Ref: 4239.L304.MR

Contract Number: CN-12858
Project Name: Bruce Highway Upgrade – Deception Bay Road Interchange
Project Number: 482286

Re: VAR204 Notice of Omission of Demolition Item being the Demolition of retaining walls below existing bridge over Bruce Highway (Annexure B, Commercial Framework, Clause 3.7)

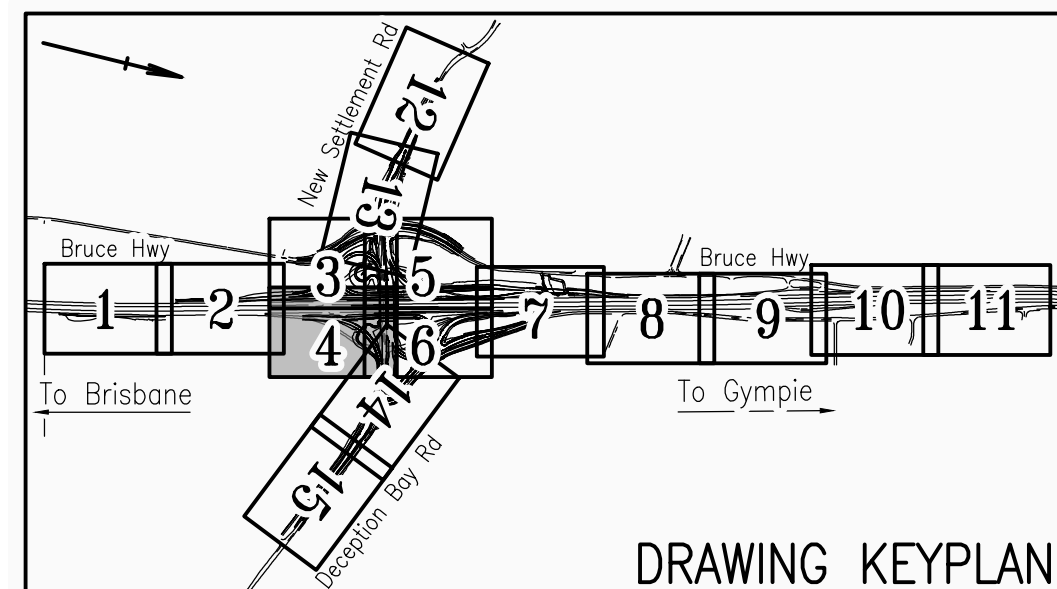
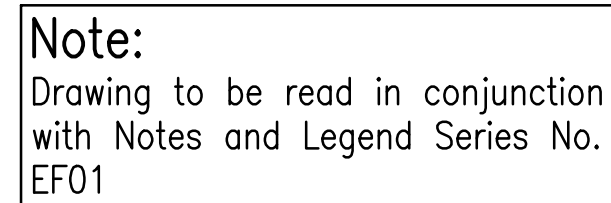
Under Clause 3.7 of Annexure B, Commercial Framework, of the General Conditions of Contract, BMD notifies the Administrator that there is an error in the Schedule of Rates and drawings in that it omits the requirement for a demolition item. BMD refers the Administrator to Drawing 361308 and 361311 provided to the Contractor following the award of the project under an RFI. These drawings included detail of retaining walls that support the spill trough batters of the existing bridge and their associated works.

The retaining walls were not part of the bridge drawing set provided at tender for the pricing of the demolition by our Subcontractors. The demolition of the retaining walls is also not included in the civil package of works listing existing retaining walls to be removed. Refer to drawing 837583 and 837587. The only elements marked for demolition at this location is the concrete barrier on each side of the highway.
